Item Name: Fwd Crosstube - High 407

DART AEROSPACE LTD		Work Order:	135106
Description: Crosstube High Fwd (407)		Part Number:	D407-667-105
Inspection Dwg: D407-667-145 Rev: C		Page 1 of 1

DRAWING NO. D407-667-145	TITLE CROSSTUBE ASS'Y (407 HIGH FWD)	REV. C	DART AEROSPACE LTD ENGINEERING ORDER		D.E.O. NO. D407-667-145-C-1	SHEET NO. SHEET 1 OF 1	SCALE NTS
DRAWN 47	CHECKED ASS	MFG. APPR. BB	APPROVED WD		DE APPR. H		
DATE 11.07.15	DATE 11.07.22	DATE 11.07.22	DATE 11/07/22		DATE 11.07.21

DRAWING NO. D407-667-145	TITLE CROSSTUBE ASS'Y (407 HIGH FWD)	REV. C	DART AEROSPACE LTD ENGINEERING ORDER		D.E.O. NO. D407-667-145-C-2	SHEET NO. SHEET 1 OF 1	SCALE NTS
DRAWN AJS	CHECKED	MFG. APPR. <i>E</i>	APPROVED <i>AP</i>		DE APPR. <i>AP</i>		
DATE 12.08.02	DATE 12.08.02	DATE 12.08.02	DATE 12.08.02		DATE 12.08.02	DATE 12.08.02

DETAIL P
BONDING STRAP INSTALLATION 2 PL

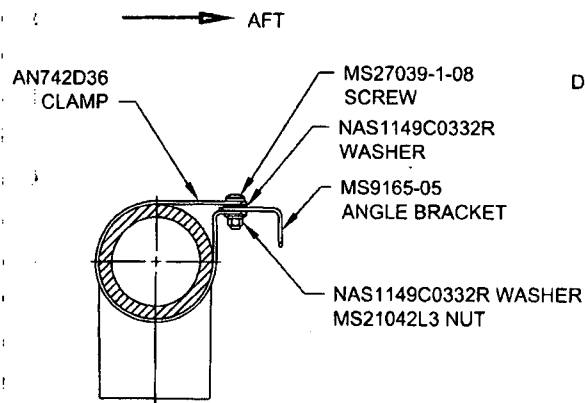
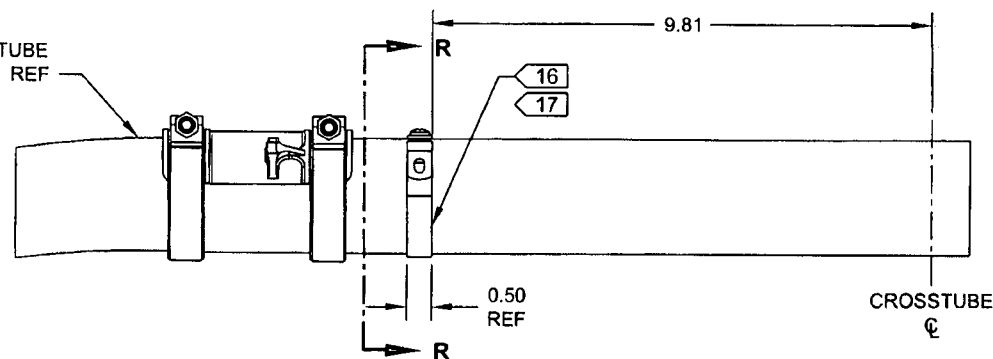
ADD ELECTRICAL GROUNDING STRAP

ITEM	QTY -145	PART NUMBER	DESCRIPTION
1	X	D407-667-145	CROSSTUBE ASSEMBLY (407 HIGH FWD)
10	2	AN742D36	CLAMP
11	2	MS9165-05	ANGLE BRACKET
12	2	MS21042L3	NUT (OR MS21042-3)
13	2	MS27039-1-08	SCREW
14	4	NAS1149C0332R	WASHER (OR AN960C10L)
